Remarks

Claims 1-31 were pending in this application prior to this response. All claims were rejected. Claims 1, 11, 12, 17, 26, and 27 have been amended herein. Claims 10 and 25 have been cancelled herein. New claims 32-34 have been added and do not add new matter to the application. Reconsideration of all rejected claims is requested.

ADVANTEDGE EXPLODED VIEW

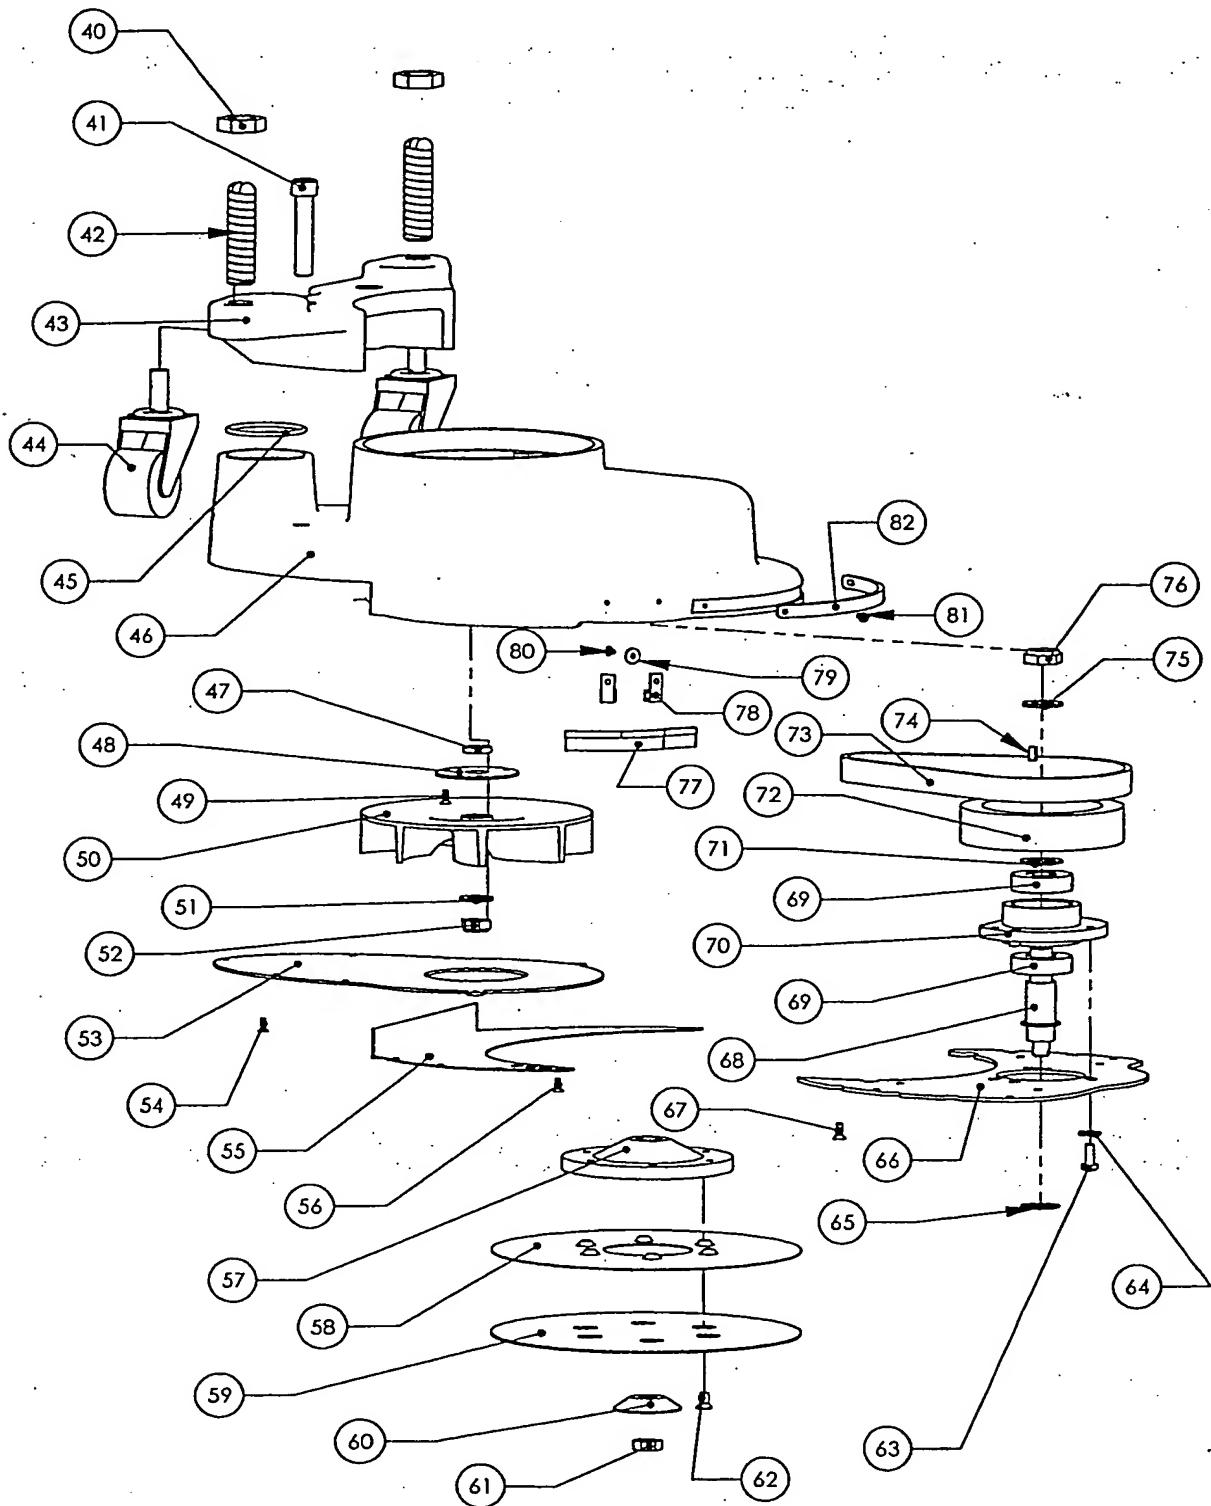
The drawings were objected to for not showing every feature of the invention specified in the claims. The office action states that the drawings do not show the housing with an opening and a rotatable abrasive disc having a diameter greater than 6"; a motor connected to the disc by a belt; and a port adjacent the second housing and a vacuum device.

Claims 10-12 and 25-27 were rejected under 35 U.S.C. §112, first paragraph. The office action states that the specification is not enabling for a fan located in the first housing. Likewise, according to the office action, the specification was not enabling for the port located in the first housing. The clarification of claims 12 and 27 provided herein and newly added Fig. 5 serve to enable the claims. The fan and first port are shown being associated with the first housing.

Fig. 5 has been added to the application and shows the features described above. The applicants note that Fig. 5 is based on a drawing filed with the provisional application (serial number 60/402,361 filed on August 8, 2002) from which the present application is based. A copy of the drawing as filed is attached hereto as attachment 1. In addition, a copy of a parts list, which was also filed with the provisional application is attached hereto as attachment 2.

Fig. 5 shows the above-described features of the claims. It is apparent from Fig. 5 that the first housing (104) has an opening because the parts underneath the housing (104) are located in the opening. The dimensions of the abrasive disc are described in the specification and are applicable to Fig. 5. The belt is shown as reference numeral 260. The applicants note that the vacuum device was not claimed. Rather, the port being connectable to a vacuum device was claimed.
